Audit of Prince of Wales Road westbound cycle track

Camden Cycling Campaign November 2020

Snagging list - ordered from east to west

Figure 8. Haverstock Hill. Bollards go right up to ASL box

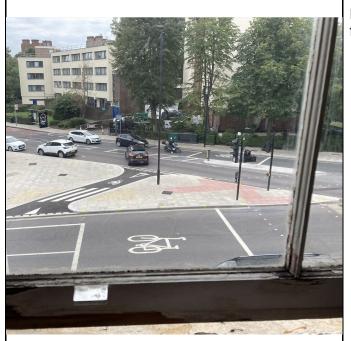
- On the Westbound approach to the Malden Road junction the cycle lane is protected with kerbs after the end of the motorcycle parking (Figure 7). But the last 10 metres (or so) are marked as a narrower ~1.5m mandatory lane where extra space in the carriageway is occupied by a right turn lane for motor traffic¹. We observed many drivers coming over the mandatory lane; for better separation from motor vehicles, we suggest a line of bollards right up to the ASL box as at the Haverstock Hill junction shown in Figure 8.

Figure 10. Close up of Malden Road junction showing the low-level lights and the two-stage right turn

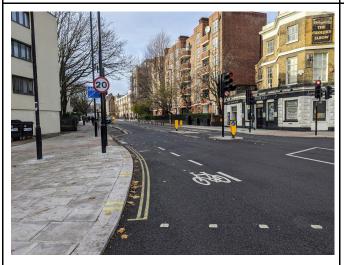
- The photo in <u>Figure 10</u> is a close up of the Malden Road junction showing the low-level lights and the two-stage right turn. We saw cyclists turning right from the right side of the ASL (where they couldn't see the early release signal) but didn't see anyone using the two-stage right is there a way to point it out with signage?
